March 7, 2023

Reconnect Austin appreciates the opportunity to comment on the draft Environmental Impact Statement for I-35 Cap Ex Central. While this project has been improved over time, there are still concerns from our organization, and from the community, which remain unaddressed. Many of these concerns have been presented to TxDOT previously, yet have not been appropriately addressed, in part due to the misleading reframing of “comment themes.” As the project of I-35

SECTION C-C

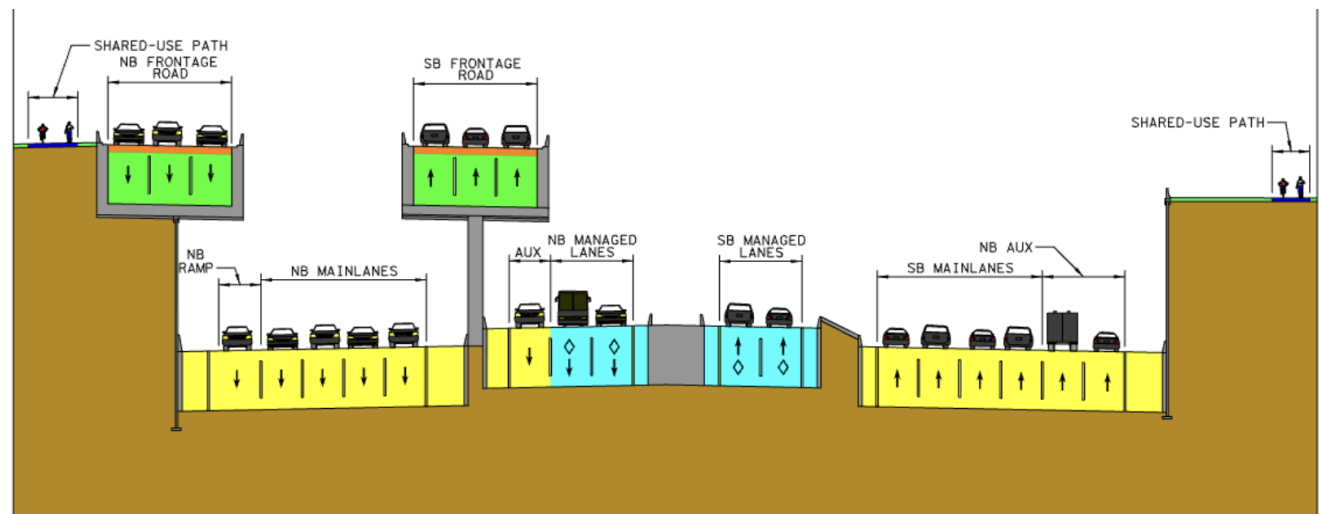
Please stop telling the public that this project adds 4 lanes to I-35. This project's ultimate footprint is 20 lanes. Telling the public otherwise is disingenuous and creates distrust.

In the heart of Austin, TxDOT should downgrade I-35 so that it fits better in the urban context, with continuous sidewalks, protected bike lanes, and no more than 8 lanes for vehicles. If TxDOT builds an urban arterial instead of a highway, the people near I-35 will enjoy better air quality, less flooding, more economic development, and greater safety.

Exhibit 3 Capacity Concept in Traditional Regional Model Assignment

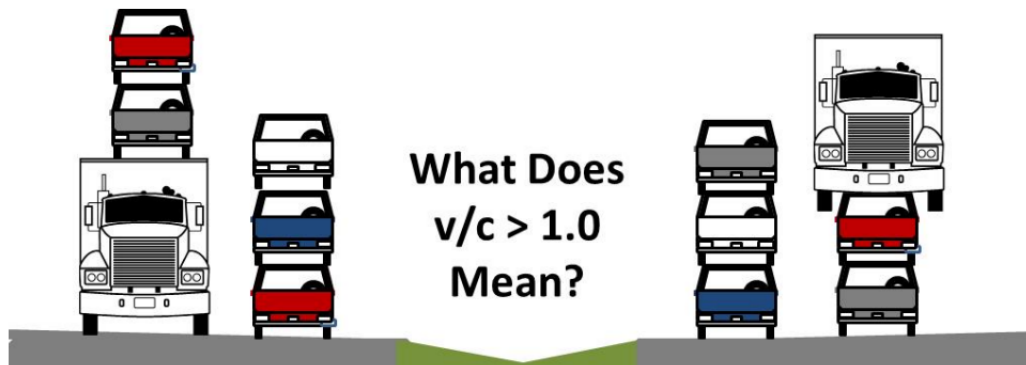
The graphic below, taken from the [Mobility Investment Priorities Project: Long-Term Central Texas IH35 Improvement Scenarios](#) (pg. 23), which TxDOT commissioned in 2013, shows what 330,000 vehicles (volume to capacity ratio exceeding 1, v/c > 1) looks like:
